# Access Compliance Report

## Public Rights-of-Way

### (Pedestrian Signals)

Intersection ID: N/A	Main Street:	Cross Street: N/A	Location: N/A
ADA ID: 3E5BB9CDF7C2	Signal Type: One Push Button-Non APS	Overall Compliance: No	Severity Score: BTN 1: N/A BTN 2: N/A No BTN: N/A
Codes/Mitigation Info/Possible Solution		Field Measurements/Component Compliance

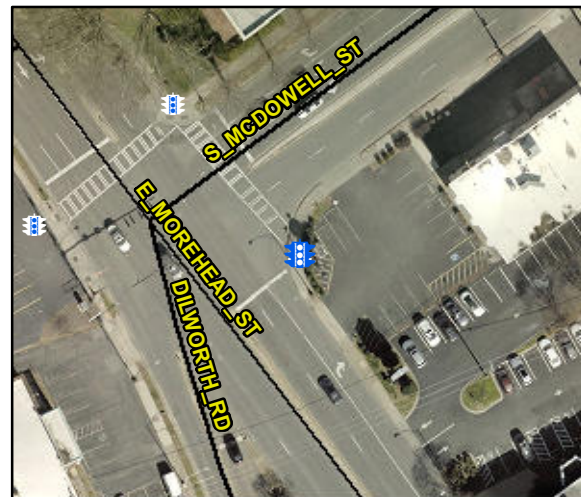
PROW/ADA: R404.2, R404.3, R406.2

Possible Solutions: Provide Push Button Extension. Remove and Replace Clear Space.
